## Meath County Council

### Planning Report

**File Number:** 2460832

**Development Address:** Phase 9, Avourwen, Platin Road, Lagavooren, Drogheda, County Meath.

Proposed site layout plan

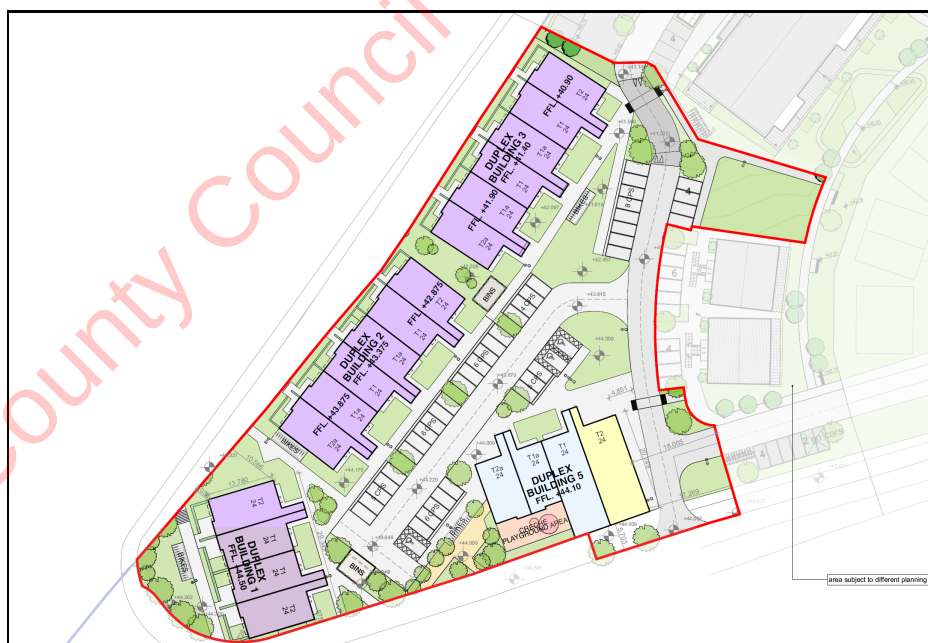
The site is approx. 0.817ha, and the proposal consists of 36 duplex units comprising 22 no. 2 bed units and 14 no. 3 bed units contained within 3 storey blocks. It is phase 9 in the Avourwen development. The proposed residential units, creche and retail unit are designed into four individual blocks. The site layout design is influenced by the positioning of the car parking and green area in the central portion of the site, with the blocks towards the perimeter.

A Housing Quality Assessment (HQA) has not been submitted as part of the application to demonstrate compliance with the minimum requirements contained in The Sustainable Urban Housing: Design Standards for New Apartments Guidelines for Planning Authorities 2023. Further information shall be requested.

As stated above a Housing Quality Assessment as not been provided by the applicant. It's unclear from reviewing the site layout plan whether the minimum standards for private open space have been achieved.

2. The applicant is required to submit a Housing Quality Assessment (HQA) to demonstrate how each of the proposed duplex units accord with all the minimum requirements contained in The Sustainable Urban Housing: Design Standards for New Apartments Guidelines for Planning Authorities 2023. The applicant shall submit revised plans clearly numbering each unit and showing compliance with the minimum requirements of these guidelines.

4. The applicant shall submit a revised plans identifying the location and size in sqm of the proposed private open for each duplex unit and communal open space provision. The proposed private open and communal open space shall accord with the minimum requirements contained in The Sustainable Urban Housing: Design Standards for New Apartments Guidelines for Planning Authorities 2023.

Extract Landscape plan permitted under LB201937/ ABP 310837-21

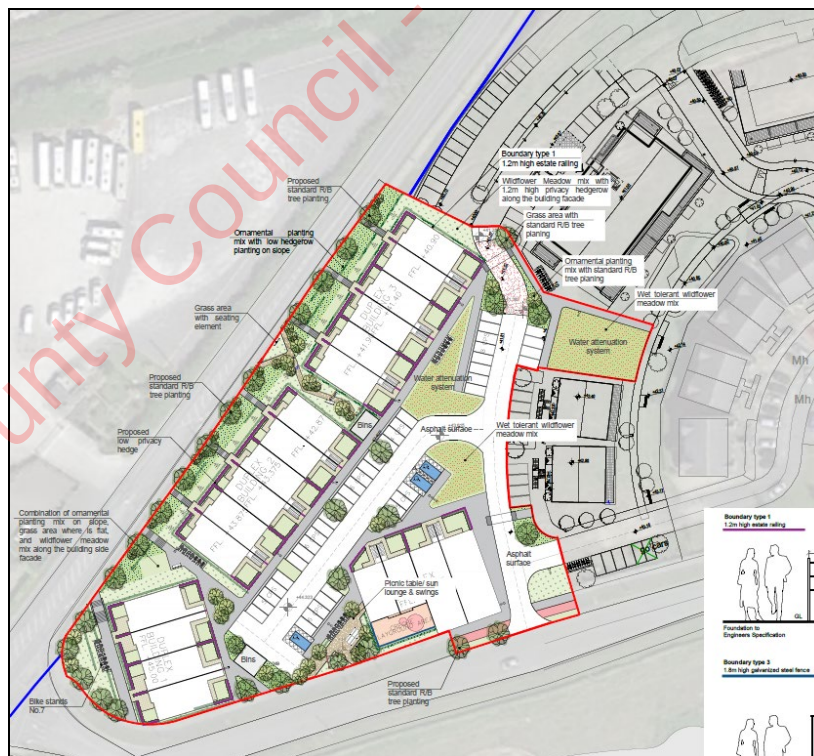
DM OBJ 26: Public open space shall be provided for residential development at a minimum rate of 15% of total site area. In all cases lands zoned F1 Open Space, G1 Community Infrastructure and H1 High Amenity cannot be included as part of the 15%. Each residential development proposal shall be accompanied by a statement setting out how the scheme complies with this requirement.

Sustainable Residential Development and Compact Settlement guidelines allow for a reduction in public open space provision. Policy and Objective 5.1 of the guidelines states that it is a policy and objective of these Guidelines that statutory development plans include an objective(s) relating to the provision of public open space in new residential developments (and in mixed-use developments that include a residential element). The requirement in the development plan shall be for public open space provision of not less than a minimum of 10% of net site area and not more than a minimum of 15% of net site area save in exceptional circumstances. Different minimum requirements (within the 10-15% range) may be set for different areas. The minimum requirement should be justified taking into account existing public open space provision in the area and broader nature conservation and environmental considerations.

An overall area of 1,689.54 sqm of public open space is proposed by the applicant which is stated to equate to 20.6 % of the overall site area. I note the inclusion of the large open area to the northeast of the site within the calculation of open space provision. It is unclear as to whether this space is included within the open space provision for phase 8 of the development which received planning permission from An Bord Pleanála under ref no 310837-21. Condition no 2 of the Grant of Permission required the omission of "Duplex Block number 1" with the resultant space to provide a public amenity space and additional parking area for the creche facility. Clarification will be required to determine whether this large open area is to be included in the subject applications public open space provision.

5. (a) The proposal layout and design of the public open space is not considered acceptable to the Planning Authority. The public open space is interspersed between car parking areas/paths or to the side of the buildings and is not of sufficient quality for future residents to enjoy or benefit from.

The applicant is therefore requested to submit a revised site layout plan to address this issue. The revised public open space design should integrate successfully into any site layout changes made by the applicant as a result of addressing item no 1 above.

(b) The Planning Authority notes the inclusion of the public open area to the northeast of the subject site. The applicant is requested to clarify whether this open space has already been included within the open space provision for phase 8 of the adjoining residential development which received planning permission from An Bord Pleanála under ref no 310837-21 and whether it should be omitted from the public open space calculations from the subject site.

- (c) The applicant shall submit details and plans (relevant scale) demonstrating the provision of public open space for both phases 8 & 9 and ensuring both phases meet the required minimum rate of public open space.
